MODIFICATION SHEET NO. RDSO/2011/EL/MS/0399 (Rev.0) . Dated 8.8.11.

Removal of interlocks of control circuit contactors No. 126 from MCPA circuit.

3EHP281144

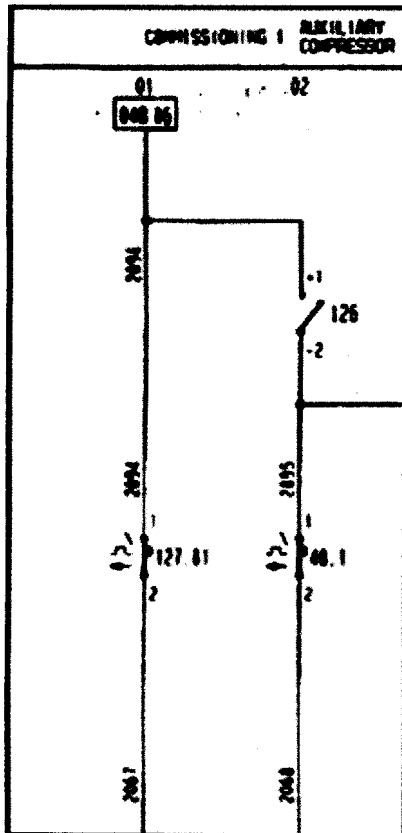
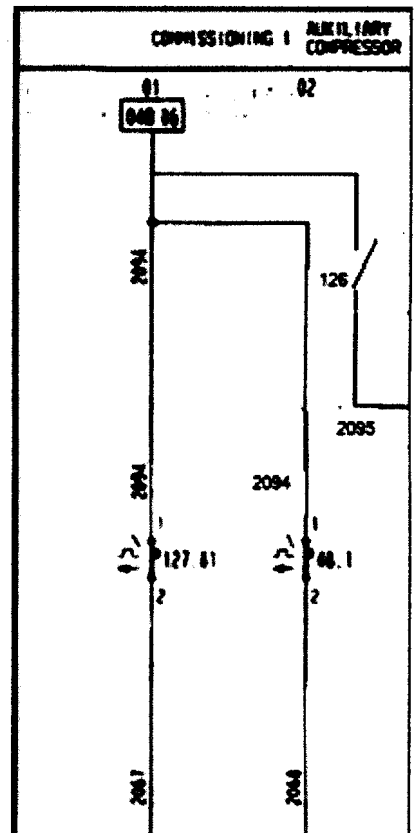
There are cases of life sign missing from different processors. On thorough investigation it was found that the interlocks of control circuit contactor no. 126 is getting flashed and as this interlock is also feeding the supply to cards, causes intermittent power supply failures to cards due to bad contact. As per ELS/LGD investigation, cause of flashing of this interlock is switching OFF of electronics while Auxiliary compressor is ON. ELS/LGD based on their experience have removed this interlock from MCPA circuit. This modification has also been done at ELS/LGD. This will not cause any change in working of MCPA as feed to contactor auxiliary compressor 48.2 comes through interlock of control circuit contactor no.126 (3EHP281146, 06E).

1. Remove the incoming strip for MCB 48.1 from Bus bar in SB-2 panel.
2. Connect 3 mm² cable at MCB 48.1 (5th from left side) incoming (where strip was removed) and other end of the cable to be looped at incoming of MCB No. 127.81 (1st from left side) at SB-2 panel.
3. Both ends of the cable to be numbered as 2094
4. Relevant circuit diagram is enclosed.
